SUBJECT: UPPER MIDHILL ESTATES (15-03)

I am writing on behalf of our client, Upper Midhill Estates, LLC, to transmit the information identified in the City's November 19th incompleteness determination and to request that the application for the Upper Midhill Estates Subdivision (SUB-15-03) be deemed complete. The following has been provided to document our response to each of the requests listed within the November 19th incompleteness notification. The applicant is providing all of the missing information identified in the incompleteness determination as required by ORS 227.178(2)(a).

Incomplete items per the Planning Department are as follows:

SHEET TITLE
 SITE PLAN
 SHEET NUMBER
C210

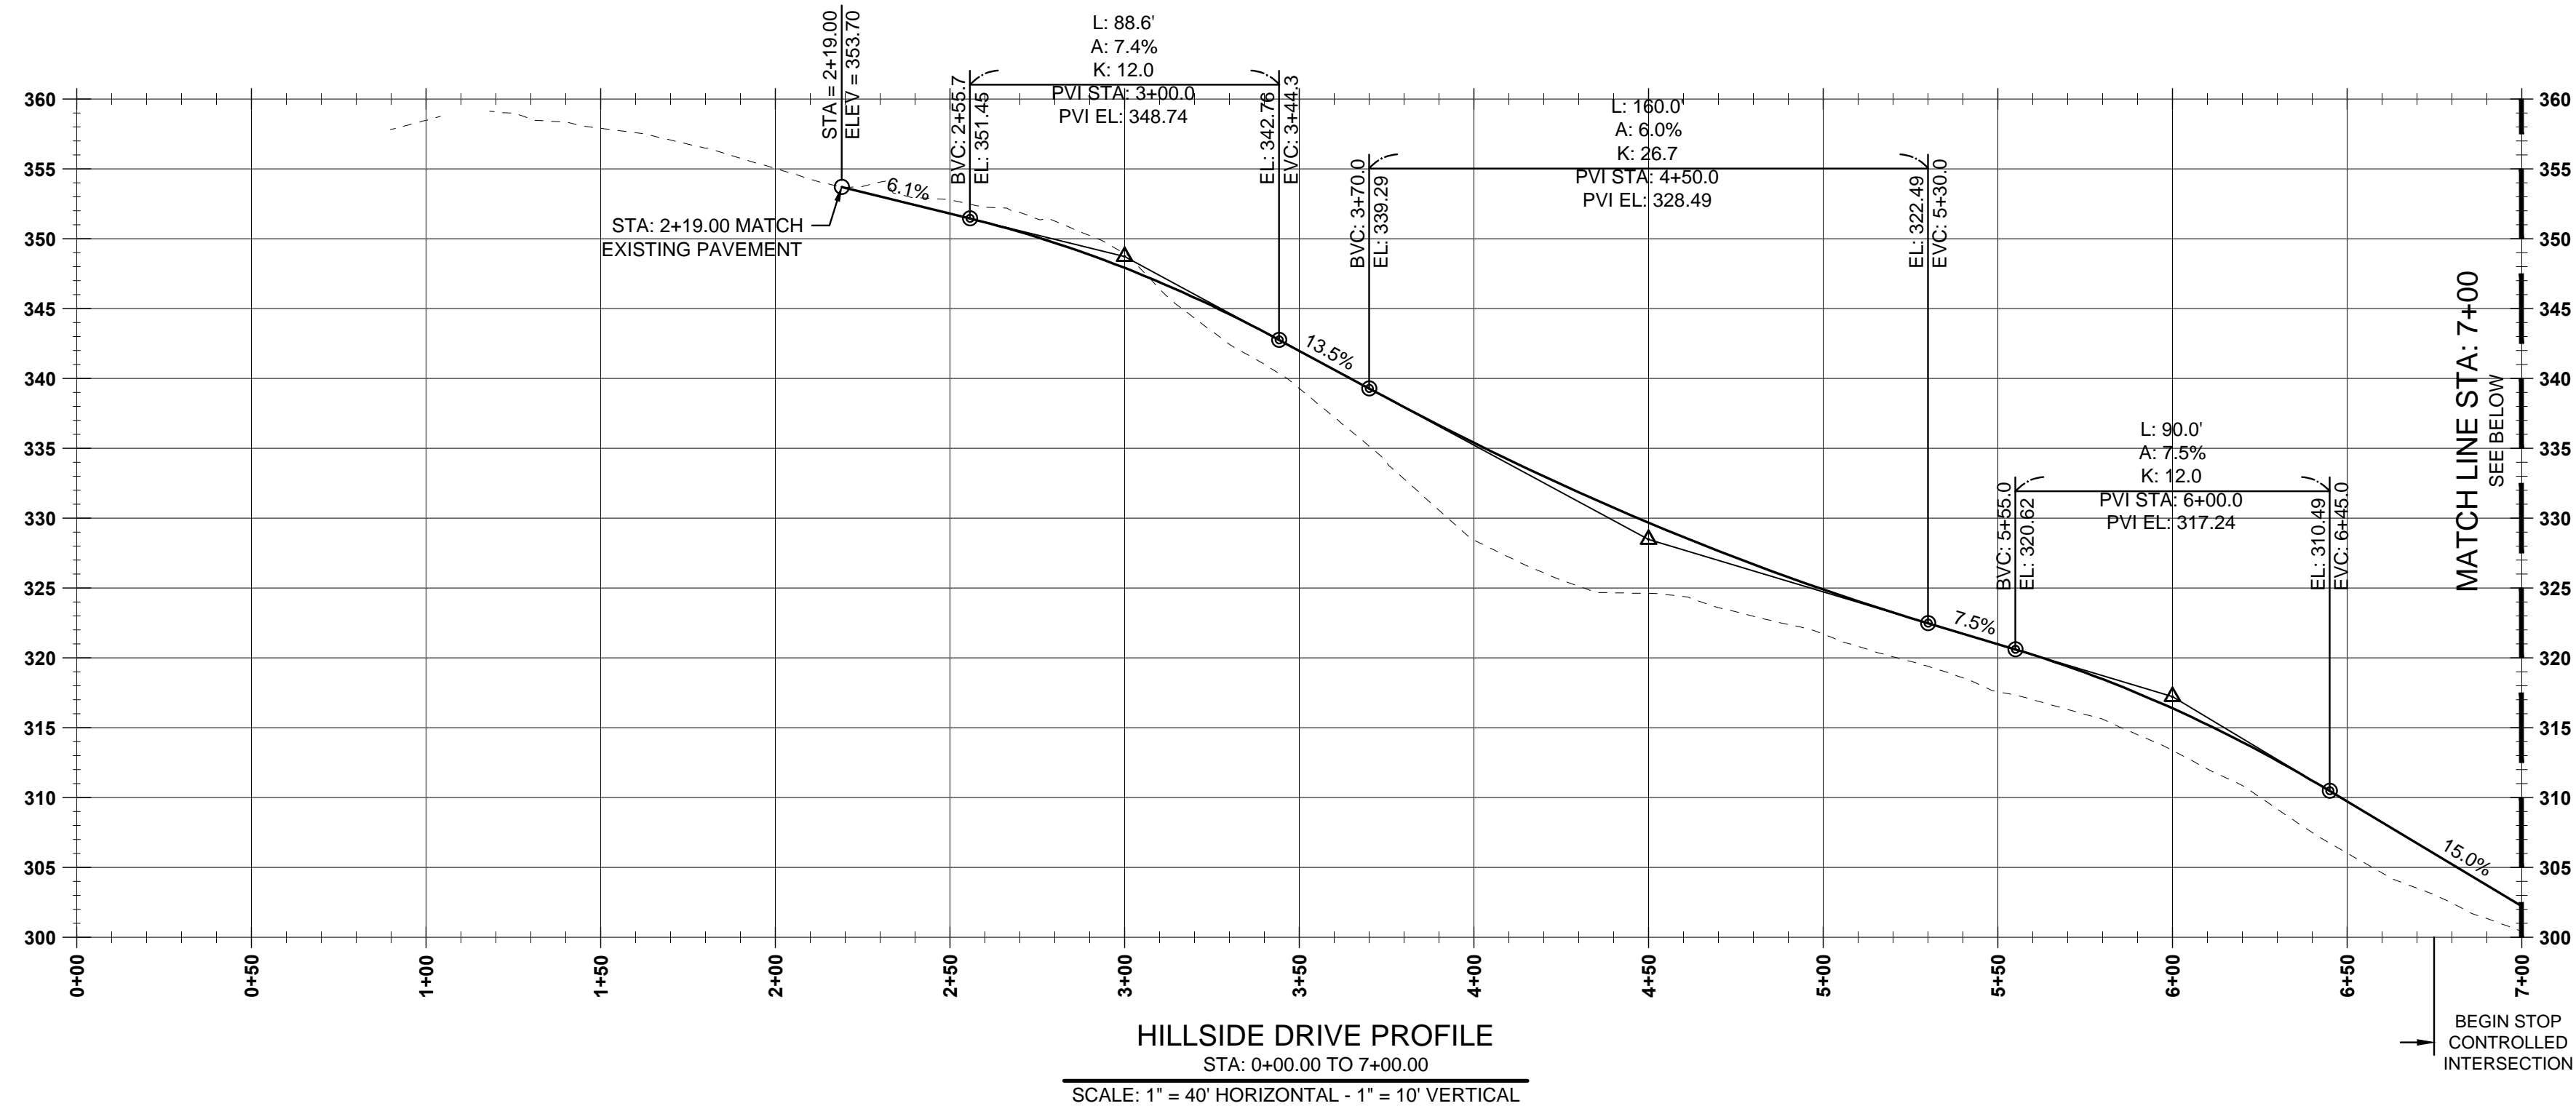
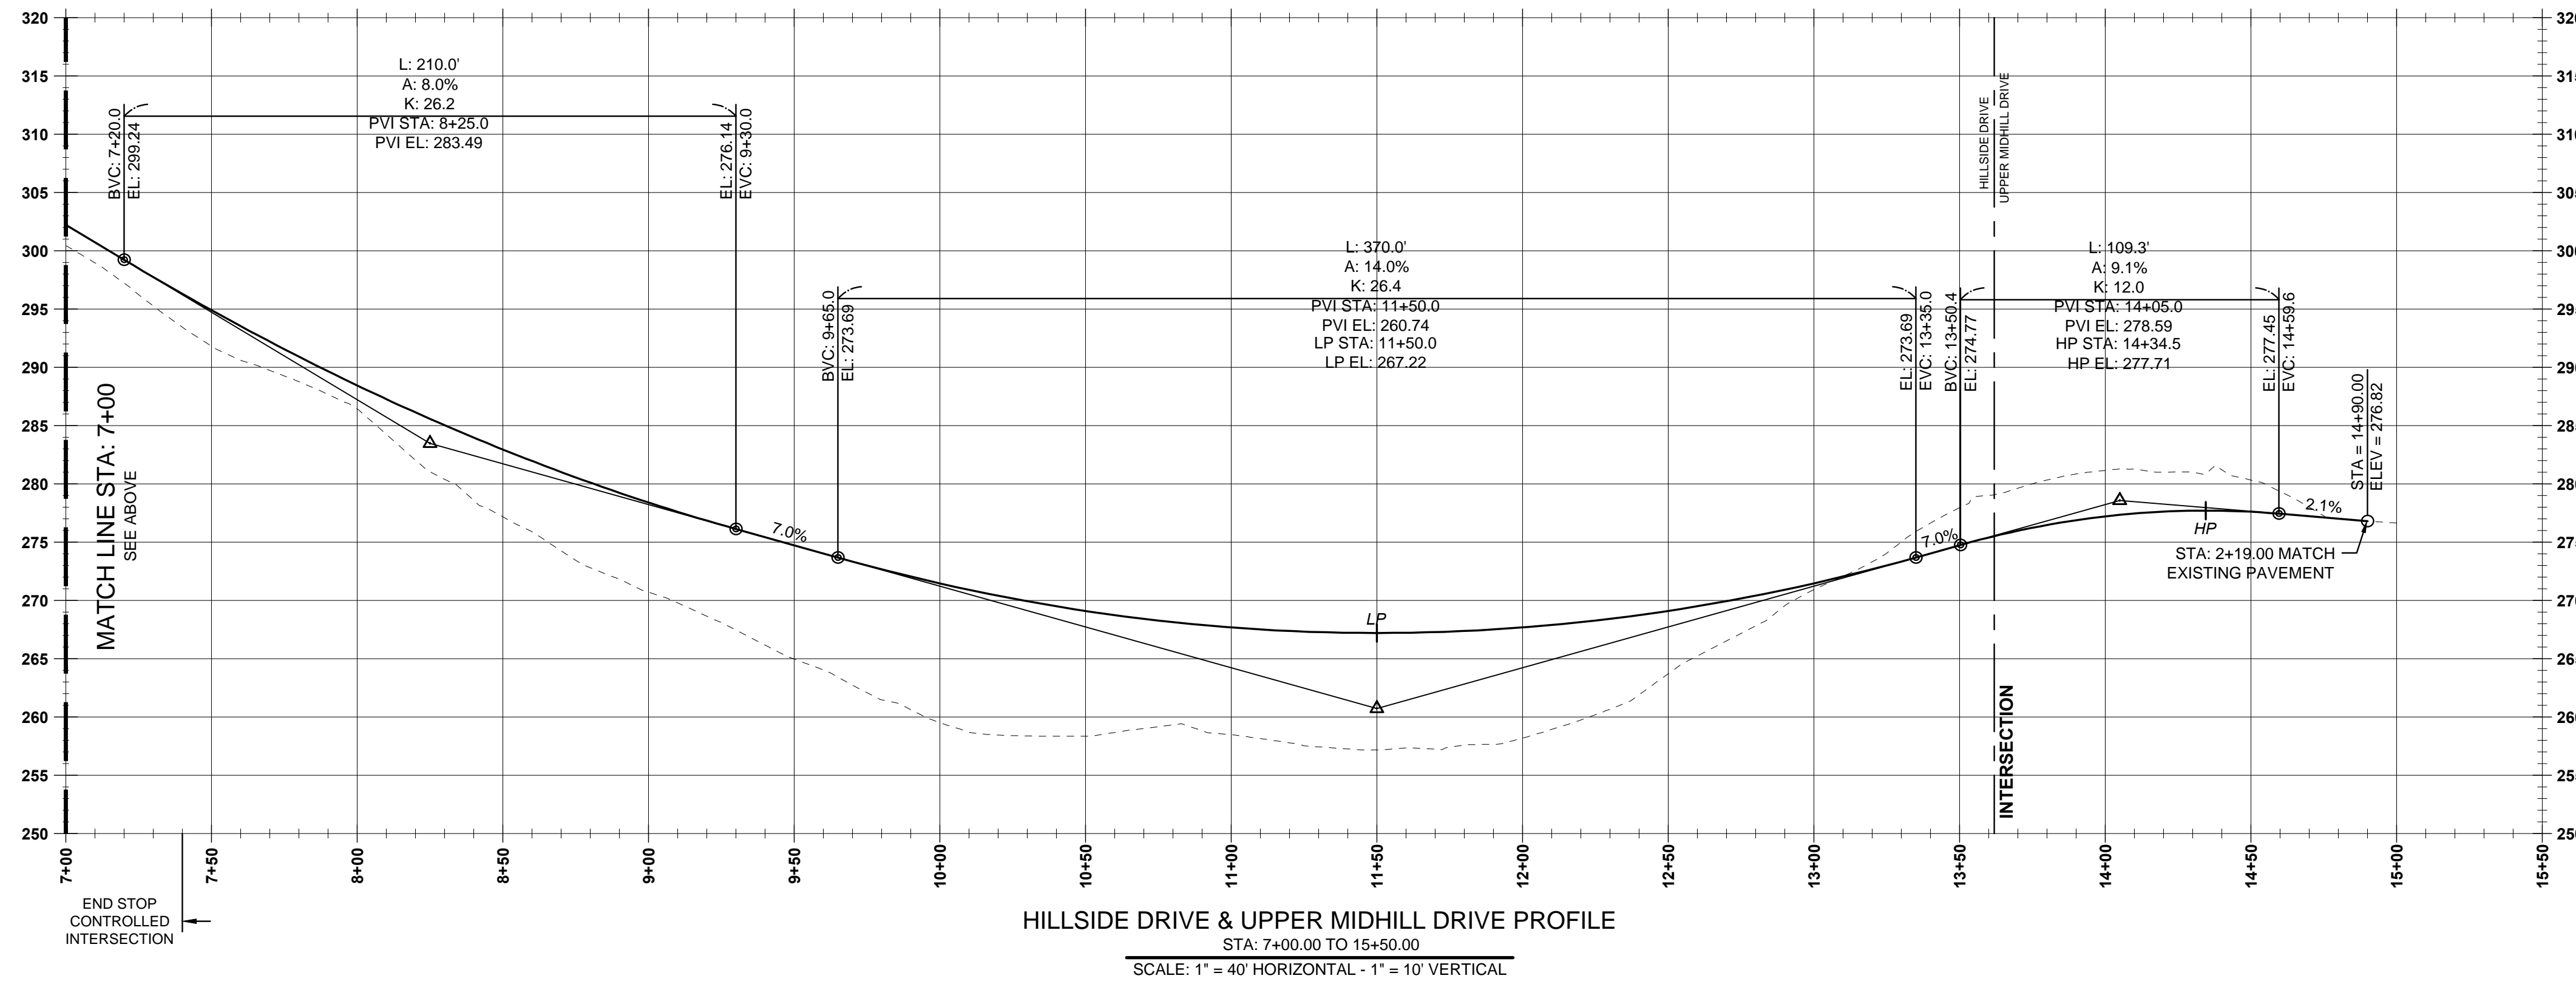
11. CDC Chapter 85.170(A) Grading. Please relocate/show retaining walls and "*proposed gravel outfall*" (as shown on sheet C210 map and legend) within the site boundaries and not on adjacent properties unless easements for those facilities can be provided.

24. Sheet C210: 6' sidewalk on curb tight sidewalk. 6.5' including curb. Why there is a stop in the middle of the roadway? Provide new street signs. Show location of new street sign and pole.

Applicant's Finding: The Applicant has adjusted the sidewalk in the typical sections. The stop sign has been removed. A new street sign has been added between lot 15 and Tract C.
